STATE OF MAINE
DEPARTMENT OF TRANSPORTATION
16 STATE HOUSE STATION
AUGUSTA, MAINE 04333-0016

December 29, 2022
Subject: Acadia Gateway
State WIN: 017163.03
Location: Trenton
Amendment No. 3

ACADIA GATEWAY FACILITY

INTERMODAL AND WELCOME CENTER

SHEET NUMBER
C403

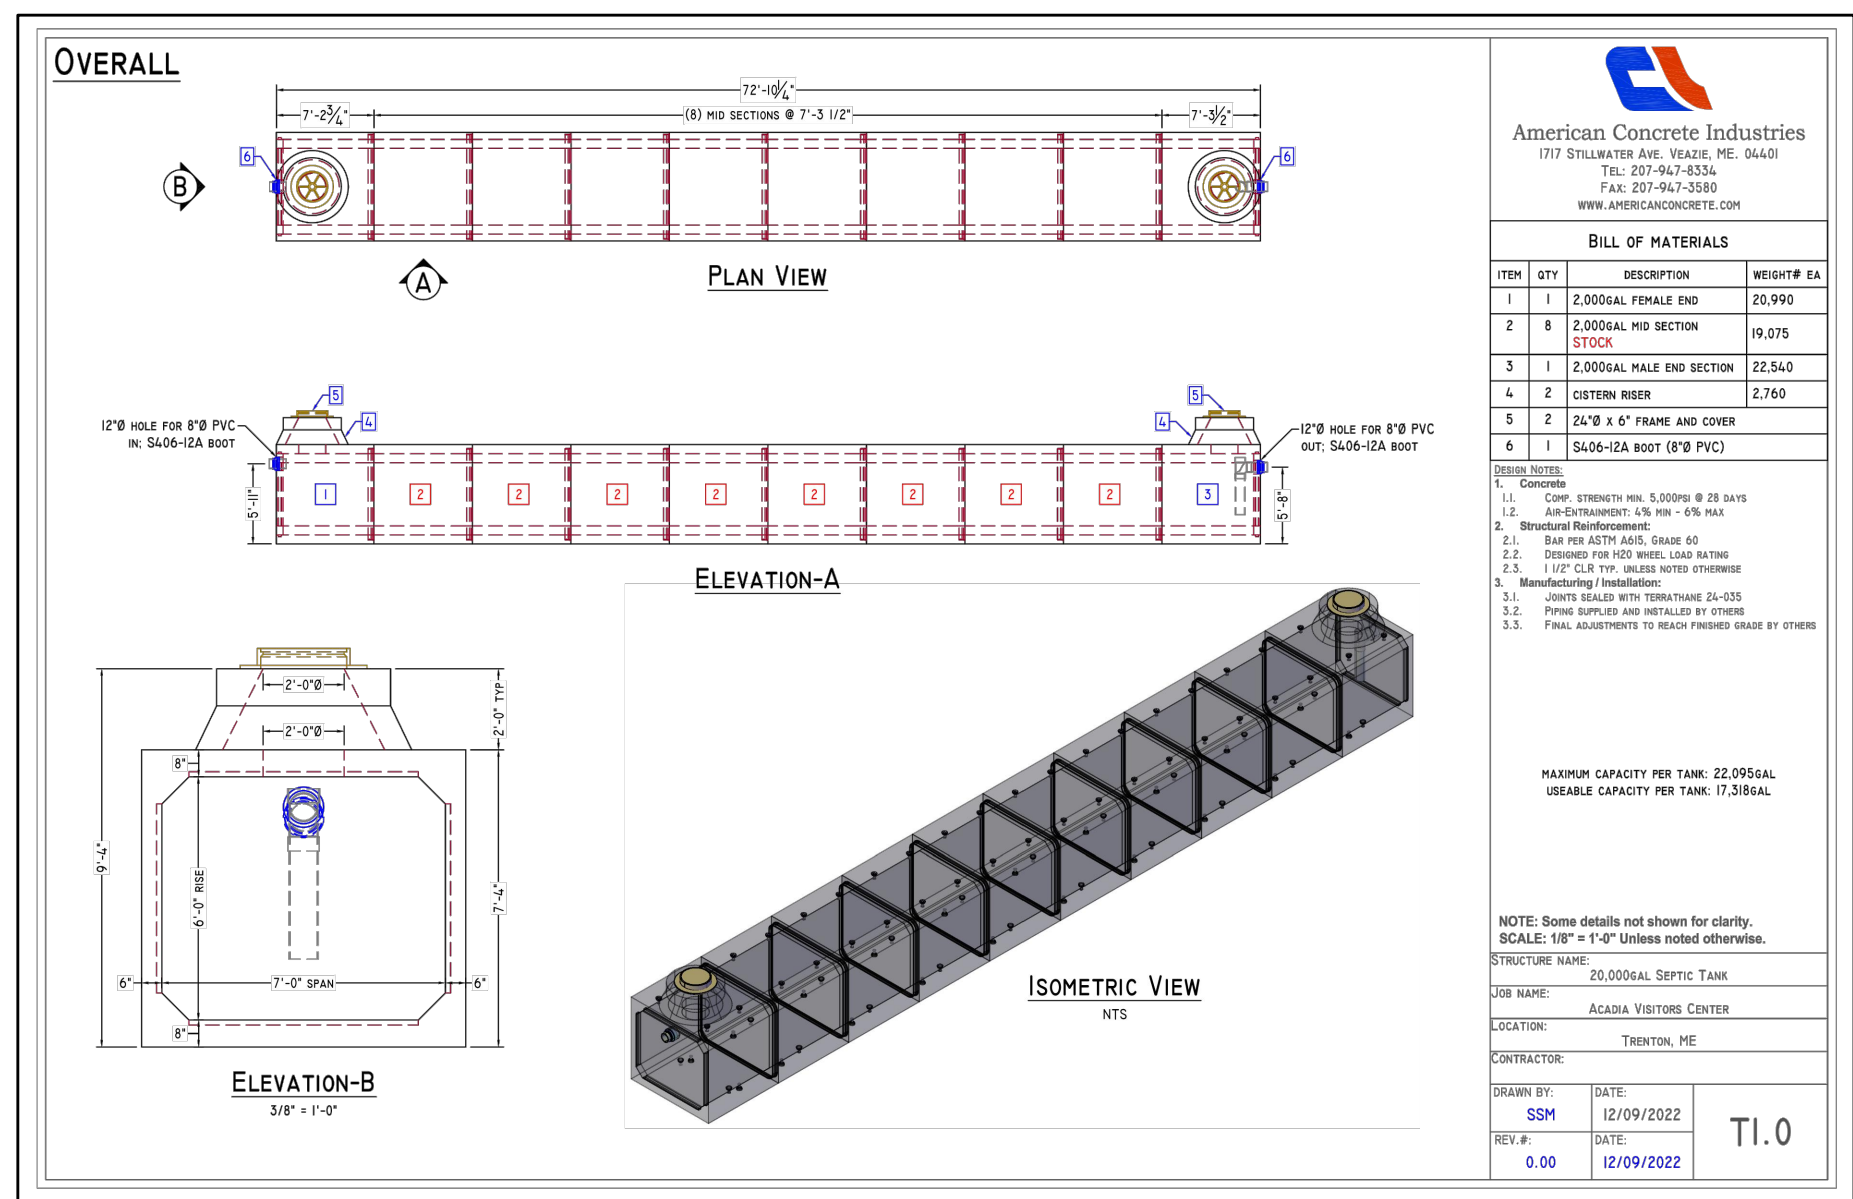
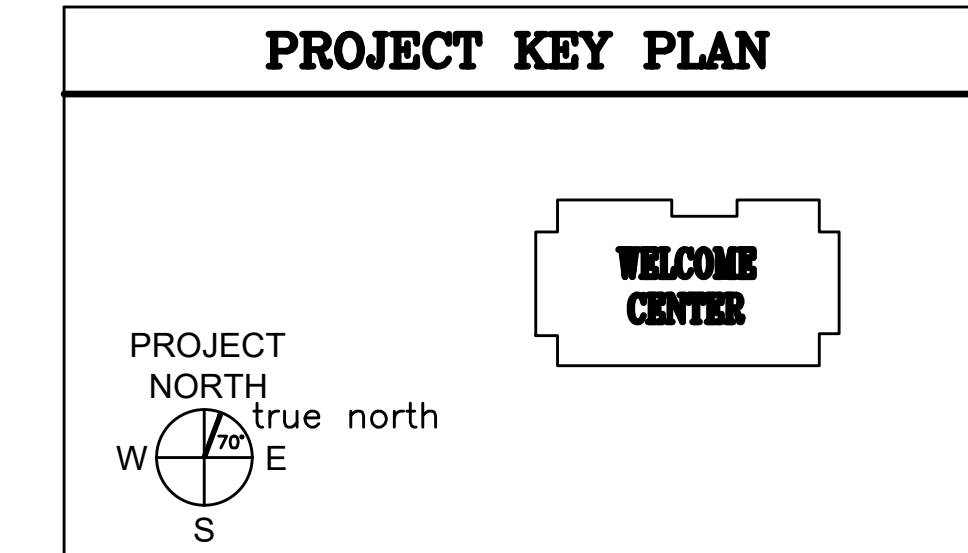
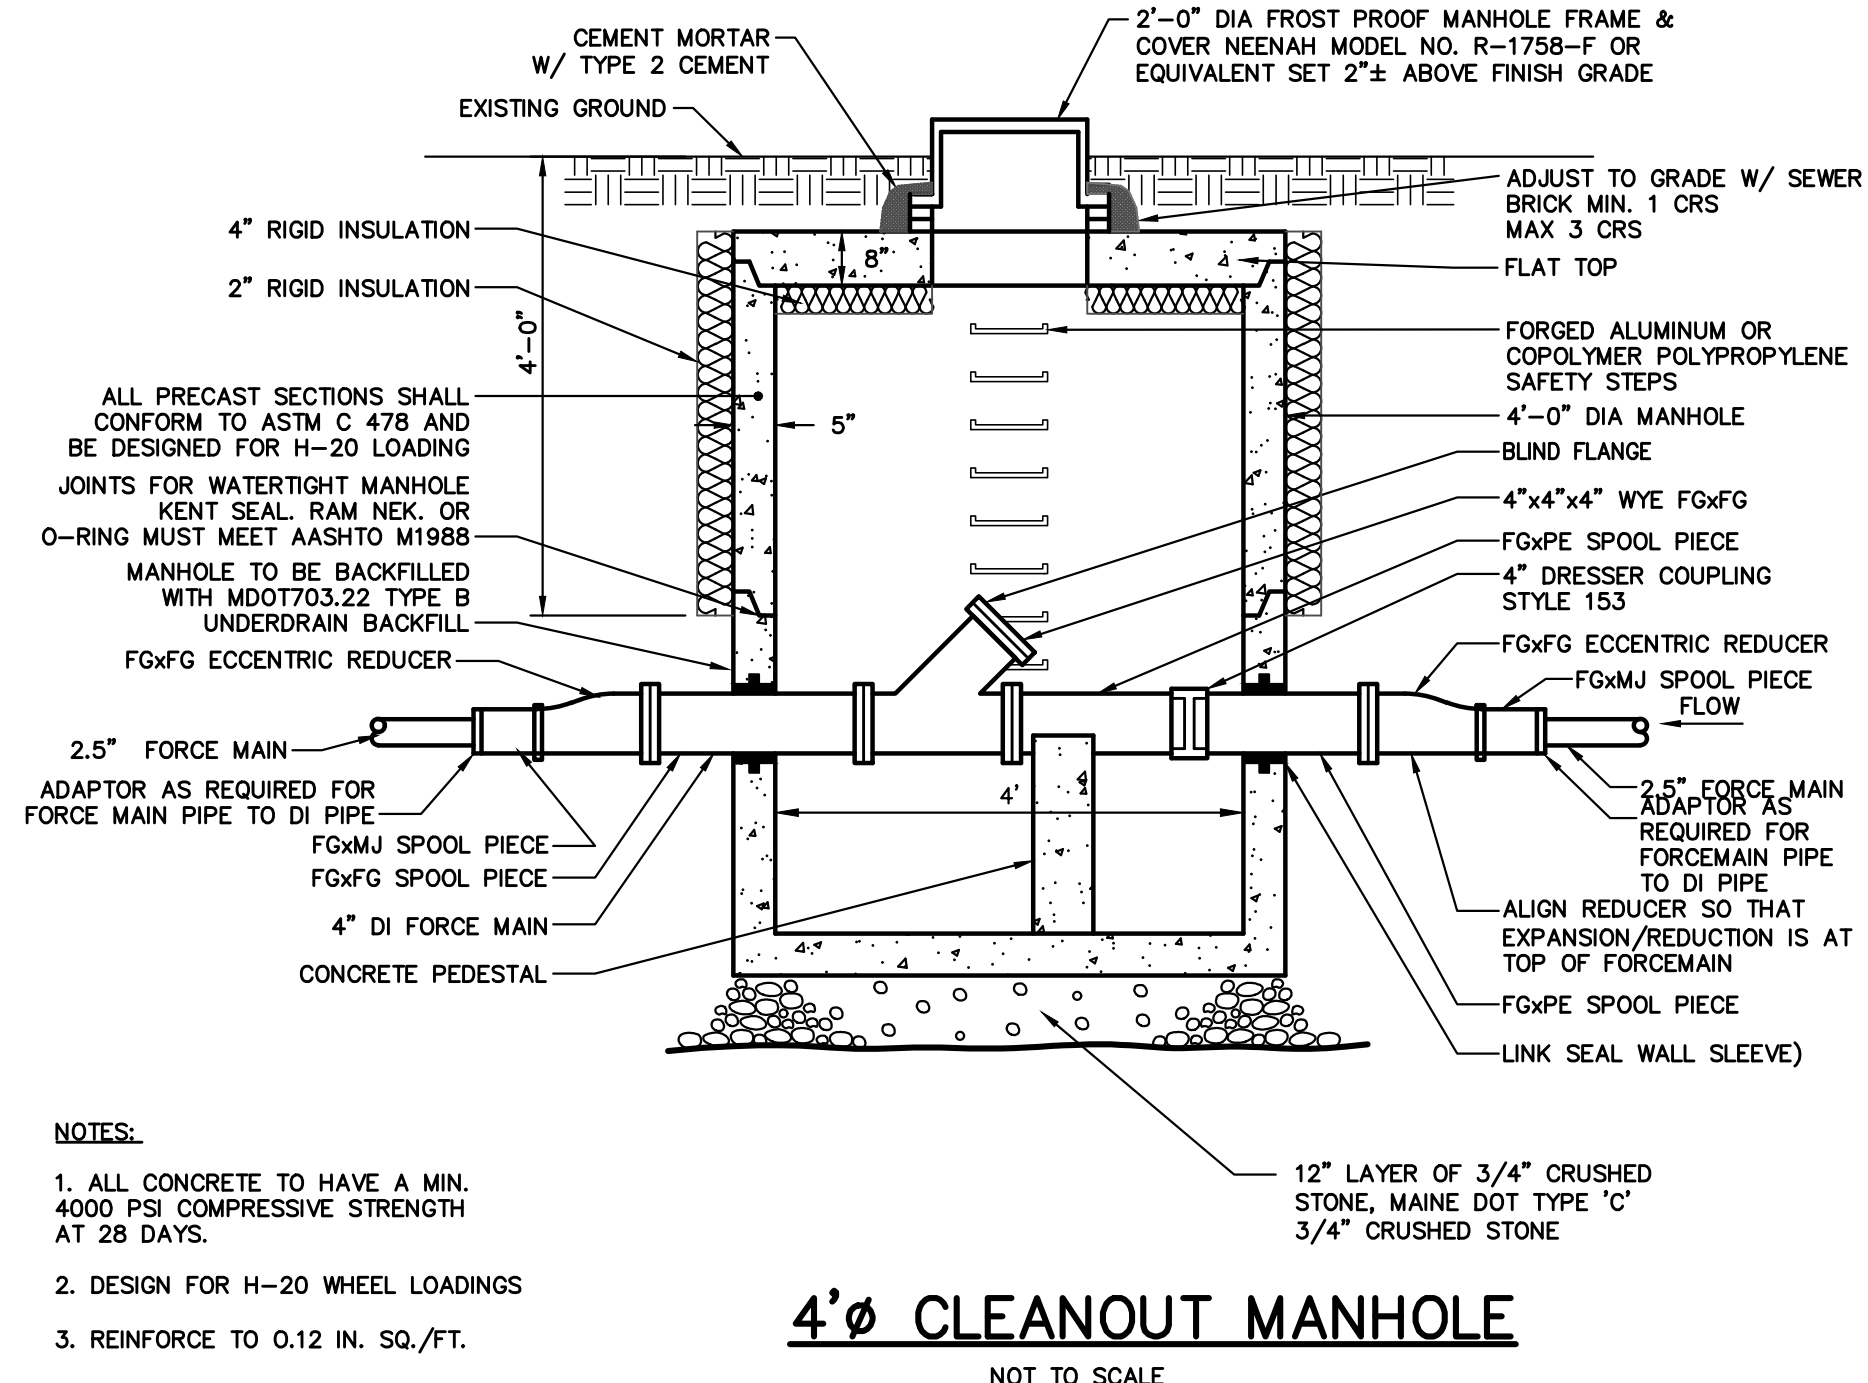
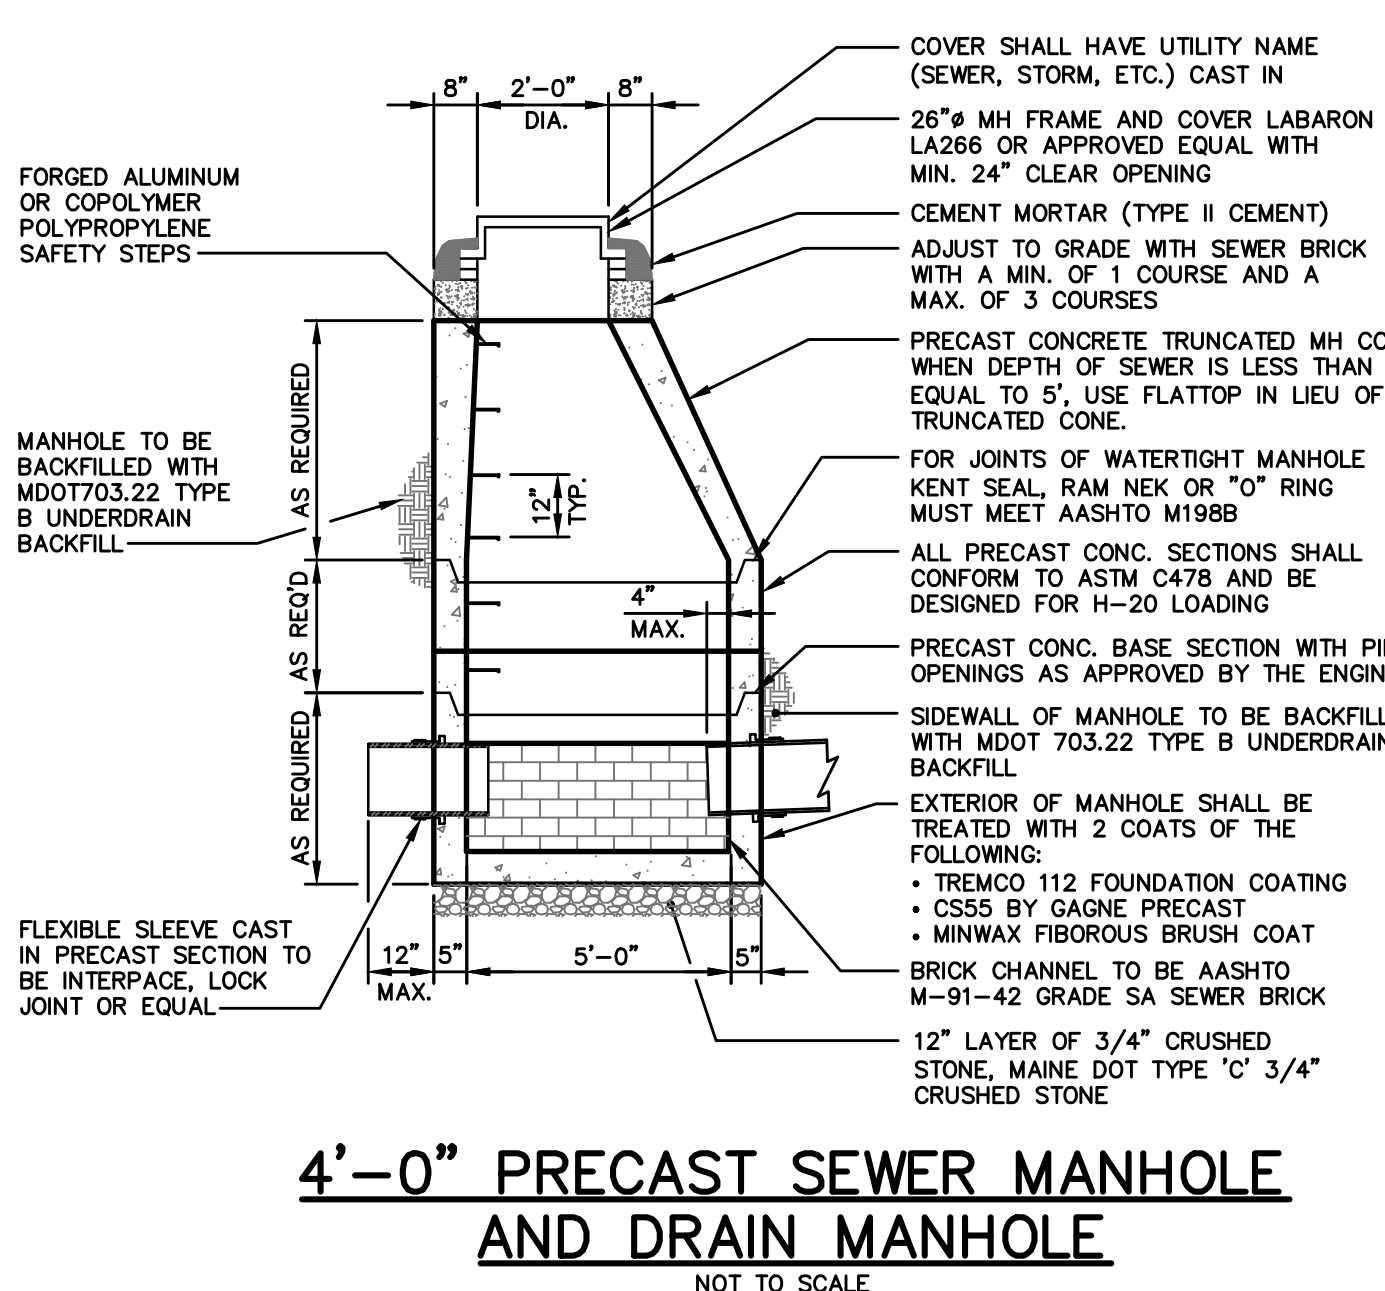
AMENDMENT #2 REVISIONS:
- REVISED SEPTIC DETAILS
